RHODE ISLAND DEPARTMENT OF TRANSPORTATION

**Bridge Group 53 - Union Village RR**

NOTICE TO PROSPECTIVE BIDDERS

ADDENDUM NO. 3 Prospective bidders and all concerned are hereby notified of the following changes in the Plans, Specifications, Proposal and Distribution of Quantities for this contract. These changes shall be incorporated in the Plans, Specifications, Proposal and Distribution of Quantities, and shall become an integral part of the Contract Documents.

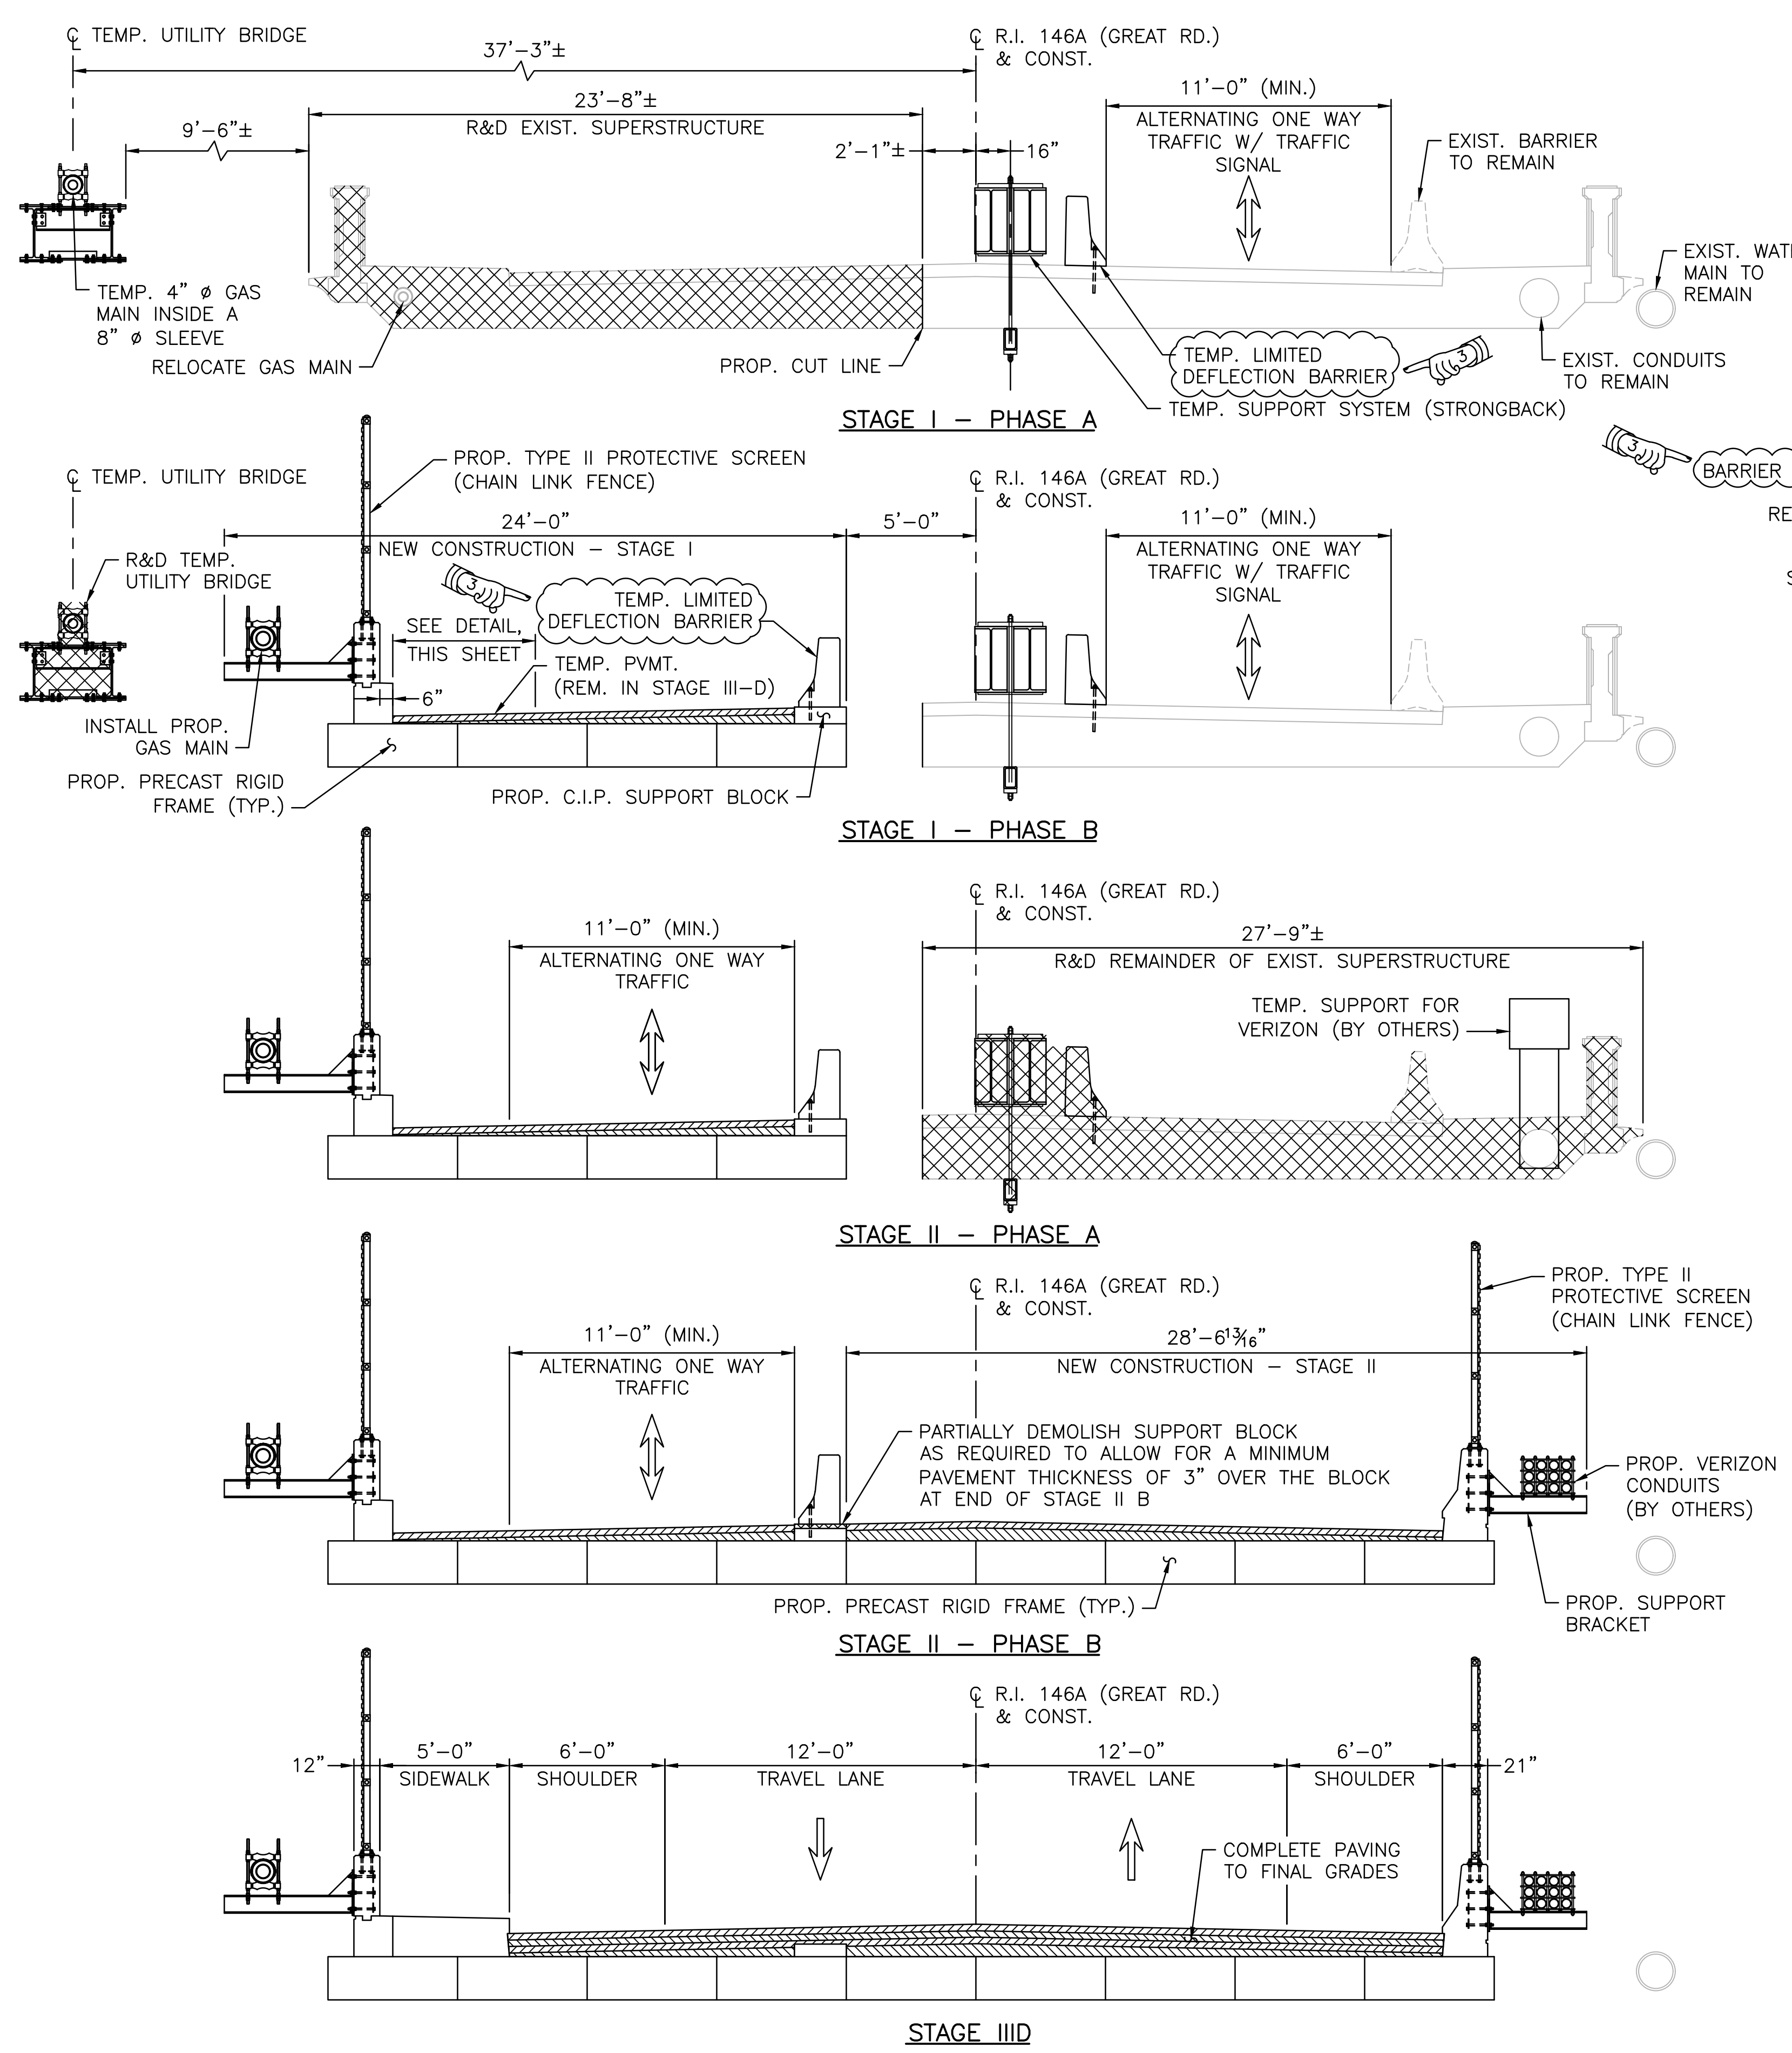
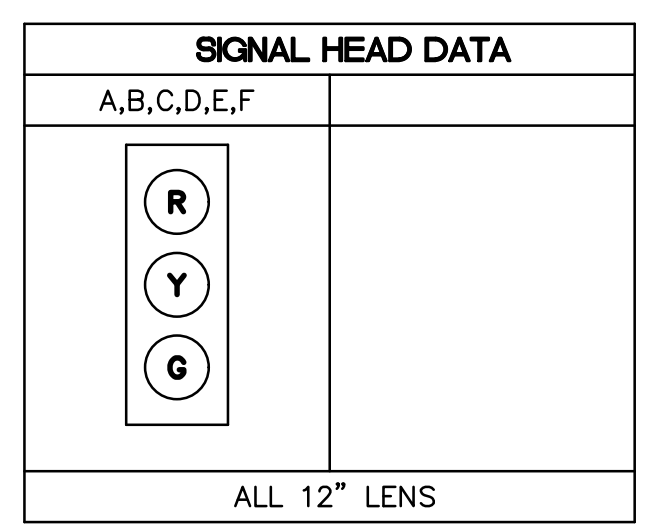
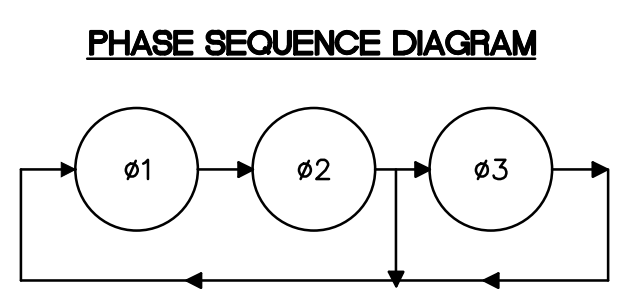
19. VOLUME 1 SHEET 33 - TEMPORARY SIGNAL PLAN  
Remove and replace Sheet 33 in its entirety with revised Sheet 33 (R-1) attached to this Addendum No. 3. Line types have been updated to display correctly based on Sheet 2 revisions.
